Subject: Crestwood Project - Preliminary Review Comments

DATE: August 26, 1999
TO: Pam Mylotta
FROM: Resty Pelayo, WDNR, RR/3, 608/267-3539 *RRAP*
RE: Recommendations and review of HNTB Site Investigation reports dated March 1998 and May 1999 for the Crestwood Area Site submitted to the Glendale Community Development Authority, Glendale, WI
CC: Darsi Foss, RR/3; Dale Ziege, RR/3

DATE: August 31, 1999
TO: Pam Mylotta - DNR, Milwaukee
FROM: Chuck Warzecha *CW*
SUBJECT: Crestwood Redevelopment Project

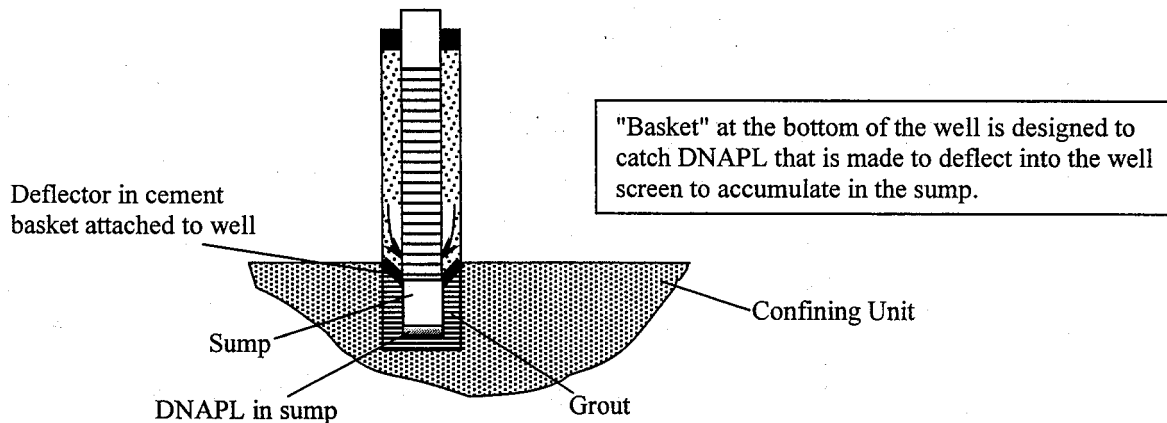
I would recommend installing *at least* two (2) specially constructed monitoring wells. An NR 141 variance may be necessary to install such wells. The monitoring well would have a sump to be able to collect and detect DNAPL (see the 4th figure of the attachment). The best locations for these two wells may be near MW-3R and MW-5. The sumps on these monitoring wells should have the deflector at the top of the underlying clay and the cement sump extending into the underlying clay to have a better chance of collecting the DNAPL that probably may be located along the top of the clay.
